JOYNER -- FLETCHER REPORT

VIRGIL C. SUMMER NUCLEAR STATION
DOCKET NO. 50/395
SOUTH CAROLINA ELECTRIC & GAS COMPANY
NOVEMBER, 1981

APPLICANT EVALUATION OF JOYNER AND FLETCHER REPORT ON
VIRGIL C. SUMMER NUCLEAR STATION
SEISMICITY STUDIES

FIGURE 2

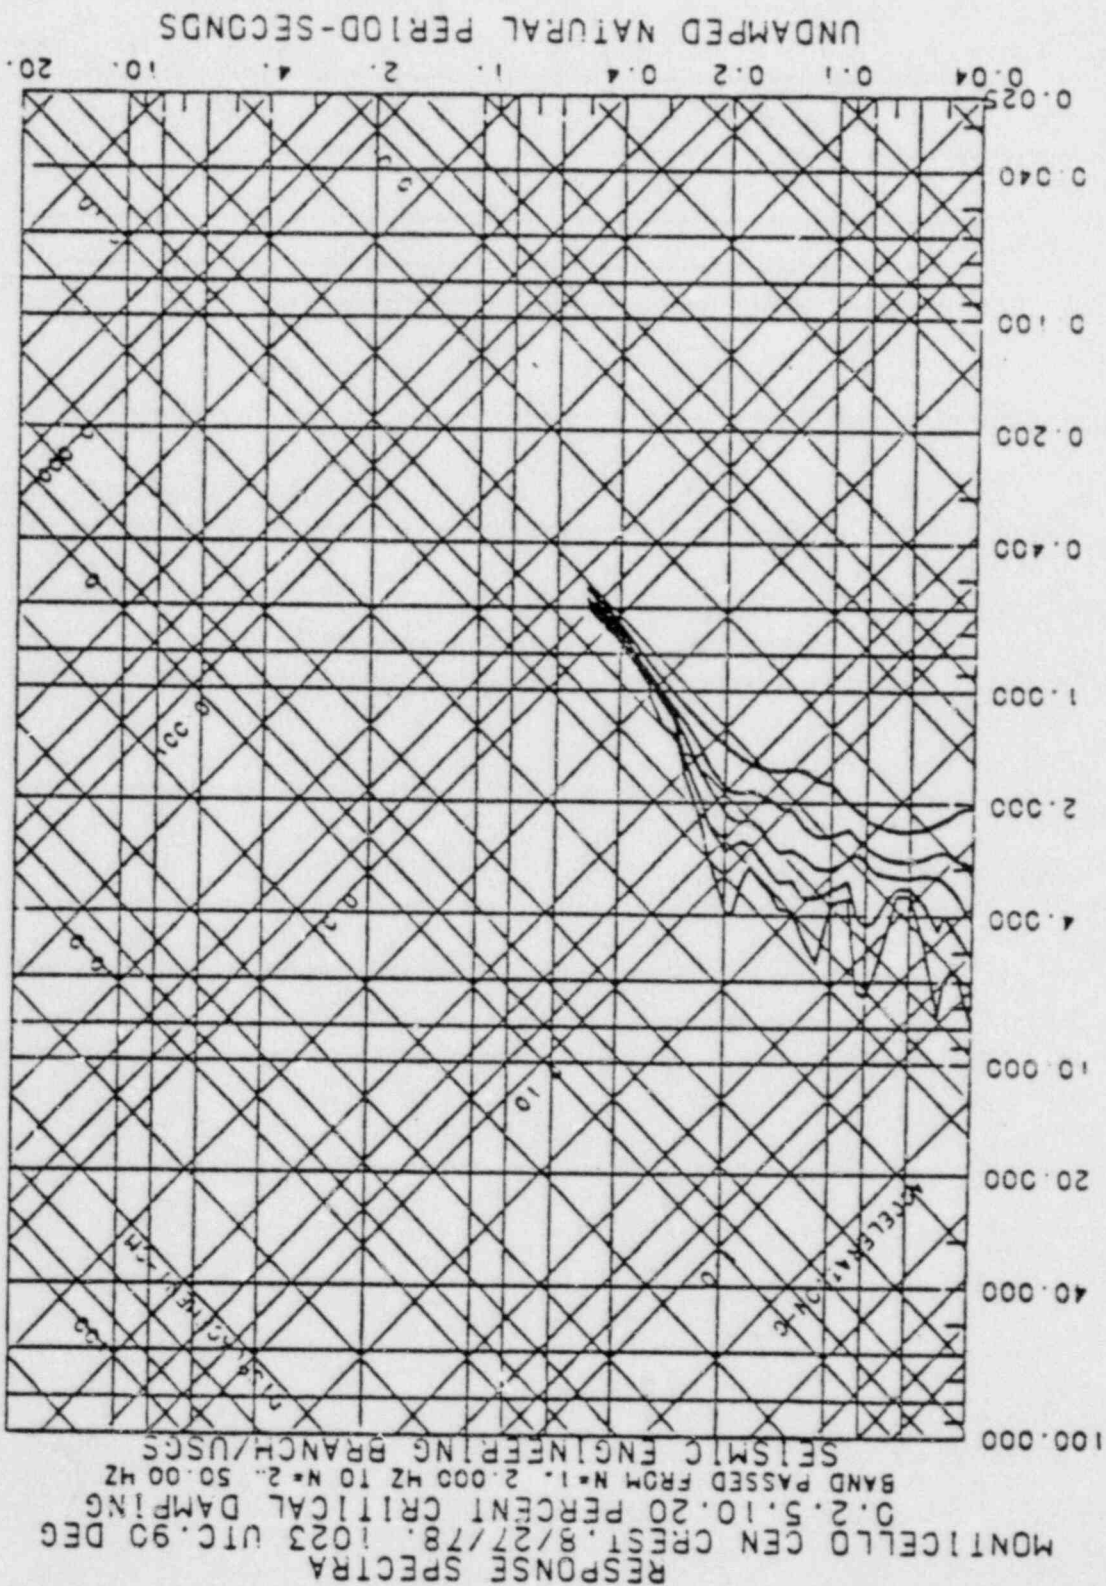
provided by Brady et al. (1981), one of which (August 27, 1978 earthquake 90° component) is reproduced here as Figure 2. Although spectra are only plotted down to a period of 0.04 seconds (up to a frequency of 25 hz), it is evident that there is no decrease of energy near 25 hz, and it is safe to assume that the spectra, if plotted at higher frequencies, would continue horizontally to frequencies as high as 35 or 40 hz, and this would indicate ground motions at those frequencies.

The Applicant has used an upper frequency of 40 hz to accurately characterize these records, making it clear that it is the record corrected for instrument response and digitized at 500 points per second to which this upper bound applies^{1/}. The choice of upper bound f_u affects estimates of stress drop $\Delta\sigma$ in the following way:

FIGURE 3

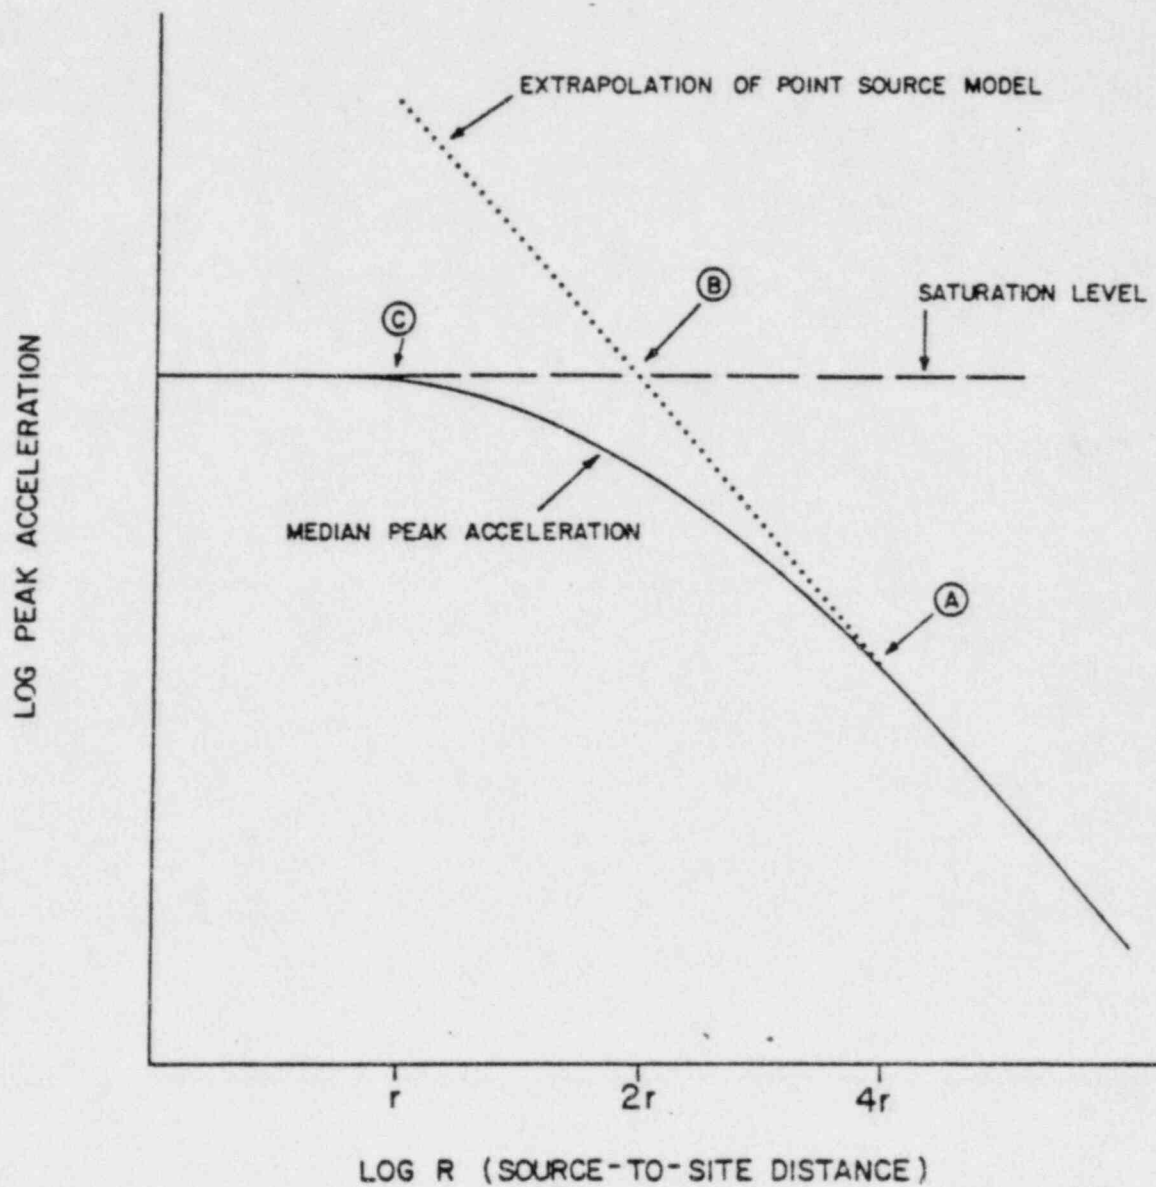
diameter ($R=2r$) gives a reasonable approximation to the saturation level." This is stated in Appendix XI of the Supplemental Seismological Investigation Report. This statement is illustrated in Figure 3 as point B, where the dotted line and dashed line cross. Whether or not Joyner and Fletcher agree with these statements, they are consistent, and the Applicant has not, "introduce(d) distance saturation in a slightly different way in Appendix XI ...," as Joyner and Fletcher state.

The Applicant notes that Joyner and Fletcher do not propose any alternative to choosing saturation distance by scaling by source size. Further, Joyner and Fletcher's mention of $R=r$ as the saturation distance appears to be motivated more by where ground motions are anticipated to decrease from any saturation level (point C on Figure 3) than what distance is appropriate to extrapolate point source models.

The Applicant agrees with Joyner and Fletcher's statement that, "... the assumption that the saturation level corresponds to the value computed at any fixed multiple of the source radius leads to the unpalatable (sic) conclusion that the saturation level decreases with magnitude." In fact the Applicant noted this effect in Appendix XI of the Supplemental Seismologic Investigation: "... earthquakes of $M_L = 5.0$ and 5.5 would have faulting diameters of 3.6 and 6.3 km, respectively. A blind application of the distance limits discussed above ($R=2r$) yield peak accelerations of $0.17g$ and $0.13g$, respectively. This does not imply that saturated peak accelerations decrease with magnitude; rather, other factors are important." Among these is the observation that smaller magnitude ($M_L \leq 5$) earthquakes are not generally known to rupture the earth's surface, particularly in the Eastern U.S. Thus it is unlikely that a site on the earth's surface would ever be in the near-field, at $R=2r$, from such an event. Use of the $R=2r$ distance saturation limit is thus conservative for such earthquakes.
